**RESPONSE TO COMMENTS
HALL PROPERTY COMMUNITY PARK**

March 9, 2007

Figure 2-7
Athletic Field Lighting Plan

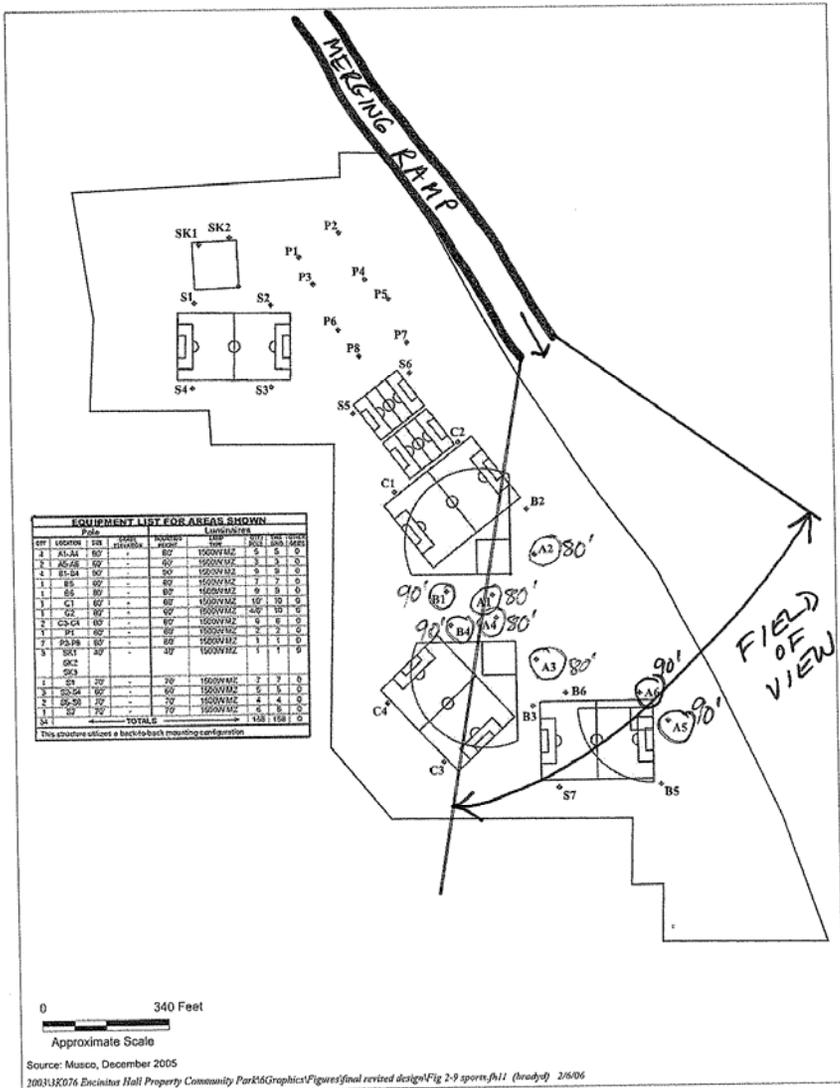
C9-6

The attached diagram referred to in Comment #C9-2 incorrectly identifies the pole heights for the A6 and B5 pole locations. Pole location A6 is noted at 90' when it is 60'. Pole B5 is 80', not the 90' noted on the attachment. The 90' poles are B1-B4 poles on the larger baseball/soccer fields. Poles locations A1-A4 are 80' high. Poles A3, A4, B3 and B4 are aimed toward the southwest corner of the property, away from the freeway on-ramp. Please also refer to Response #C9-2, above.

Figure 3.5-6

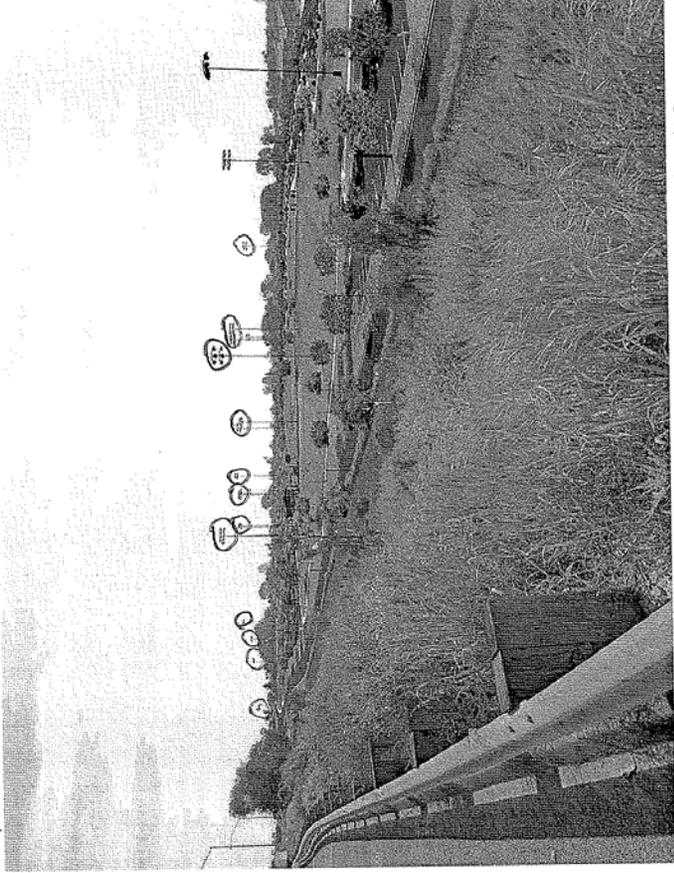
CIRCLED LUMINAIRES PRESENT SOURCES OF GLARE

C9-7

The attached figure is used to illustrate the concern related to potential glare impacts from the southbound Santa Fe Drive on-ramp. This comment is addressed in Response #C9-2, above.

Figure 3.5-11
Lighting Information

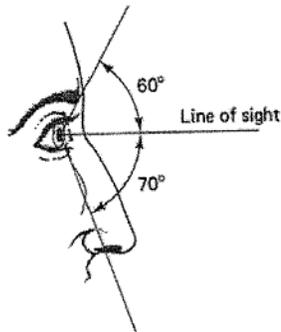
WHAT ABOUT
HORIZONTAL?
(FOR DRIVERS)

Horizontal field of view is generally considered to be 160 to 180° from line of sight. The commentor has asked the question of horizontal field of view with regard to automotive headlights. In this case, the lighting is not directly in the horizontal plane such as is the case in automotive conditions, so vertical field of view is more appropriate to consider. The lighting is mounted at a higher angle than normal to the viewer. Normal refers to an angle that is directly in the line of sight to the observer. In other words, someone has to tilt their head to see into the fixture, therefore the vertical angle is the basis for calculating potential glare. There is no doubt that the developed project will be visible from multiple viewpoints.
